## Network Keyboard 1100KI(B)

Version: V4.1.0

### Release Note

(2020-03-28)

## 2. 【Support serial port function】

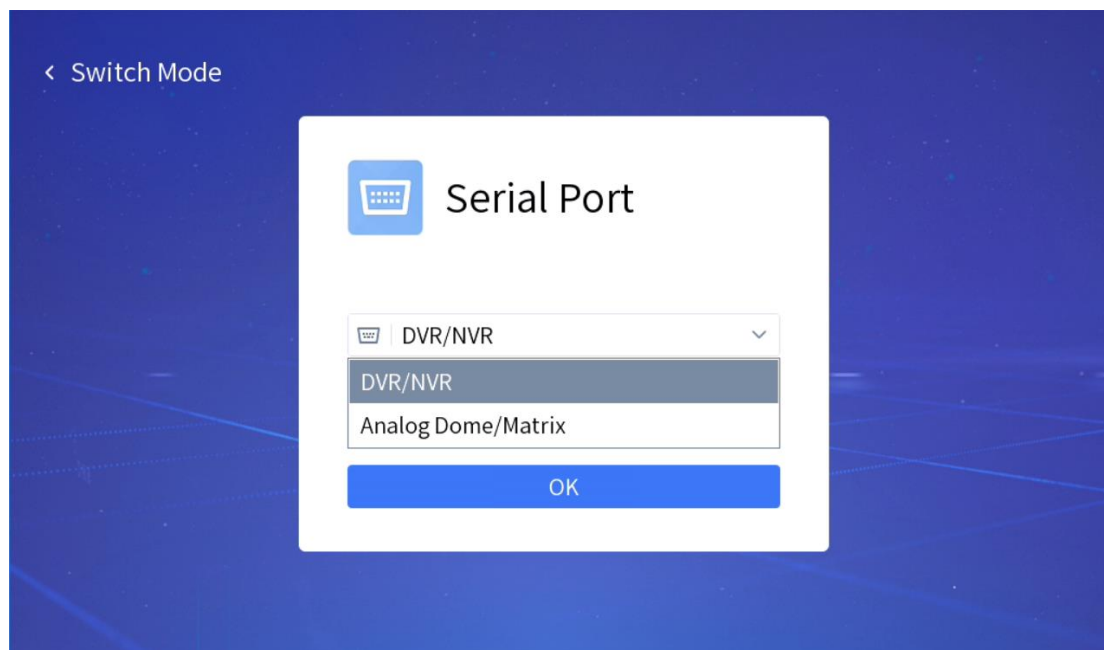
Support controlling DVR/NVR by serial port.

Support controlling analog dome/Matrix by serial port.

## 3. 【Add web client】

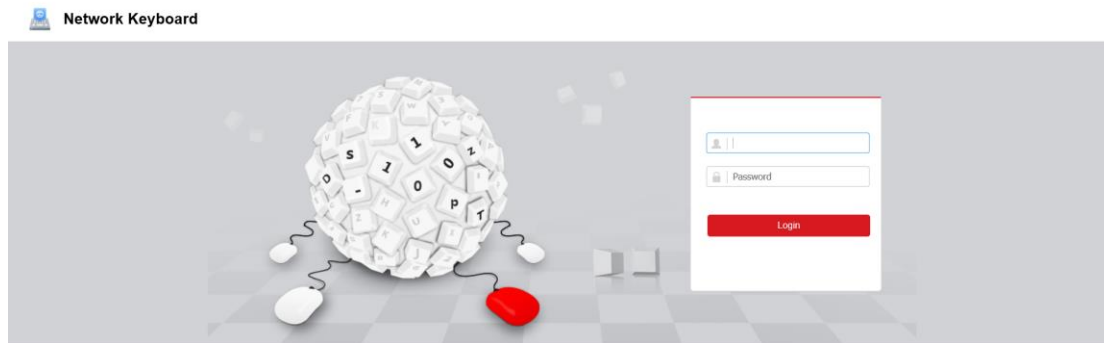
Support logging in the web client with https mode-.

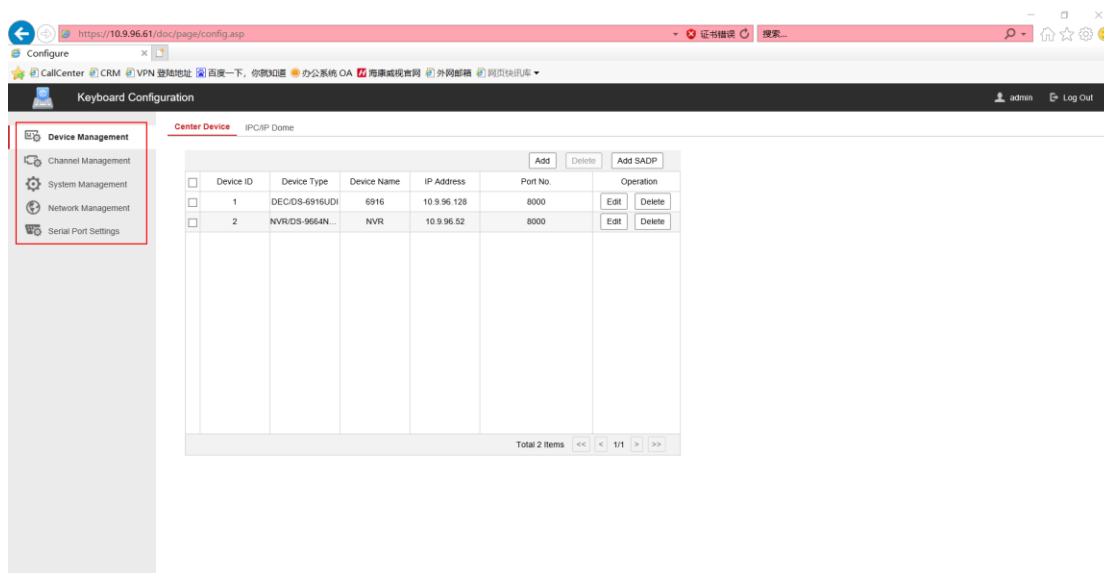
Support configuring device management, input and output channel management.

Support configuring system management on the website, including version information view, user management, system maintenance and security settings.
